Access Compliance Report

Public Rights-of-Way

Intersection ID: 10041631	Main Street: WHITEHALL_PARK_DR	Cross Street: N/A	Location: SE
ADA ID: 7BC445BDC358	Ramp Type: PerpDiag	Initial Pass/Fail: Fail	Overall Compliance: No
Codes/Mitigation Info/Possible Solution		Field Measurements/Component Compliance	
Severity Score: 33.75

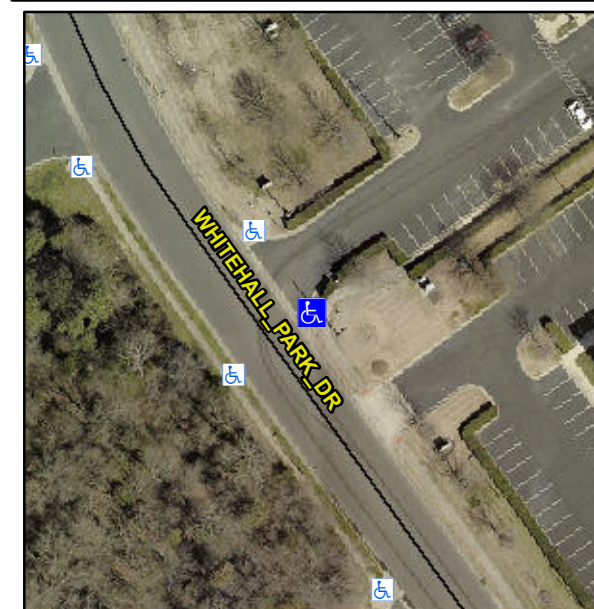
Not Found, R304.5.1, R304.5.3

Compliance	Description	Data	Compliance	Description	Data
N/A	Ramp Length (in)	65.0	Yes	Ramp Slope (%)	7.1
No	Ramp Width (in)	39.0	No	Ramp XSlope (%)	10.2
N/A	Flare Type LT	N/A	N/A	Flare Type RT	N/A
N/A	Flare Slope LT (%)	N/A	N/A	Flare Slope RT (%)	N/A
N/A	Flare Traversable LT?	N/A	N/A	Flare Traversable RT?	N/A
N/A	Landing Length (in)	N/A	N/A	DWS Provided?	N/A
N/A	Landing Width (in)	N/A	N/A	DWS Contrast?	N/A
N/A	Landing Slope (%)	N/A	N/A	DWS Length (in)	N/A
N/A	Landing X Slope (%)	N/A	N/A	DWS Full Width?	N/A
N/A	Landing Curb? (Y/N)	N/A	N/A	DWS Offset (in)	N/A
N/A	Shared Landing?	N/A			
N/A	Gutter Ponding?	N/A	N/A	Gutter Slope (%)	N/A
N/A	Gutter Lip Ht (in)	N/A	N/A	Gutter X Slope (%)	N/A
N/A	Painted X Walk1?	No	N/A	Painted X Walk2?	No
	X Walk 1 Direction	To NW		X Walk 2 Direction	To SW
N/A	X Walk 1 Width (in)	N/A	N/A	X Walk 2 Width (in)	N/A
	X Walk 1 Slope (%)	0.9		X Walk 2 Slope (%)	0.8
	X Walk 1 X Slope (%)	8.3		X Walk 2 X Slope (%)	0.6

Remove & Replace Curb Ramp With Two New Directional Ramps or Equivalent.
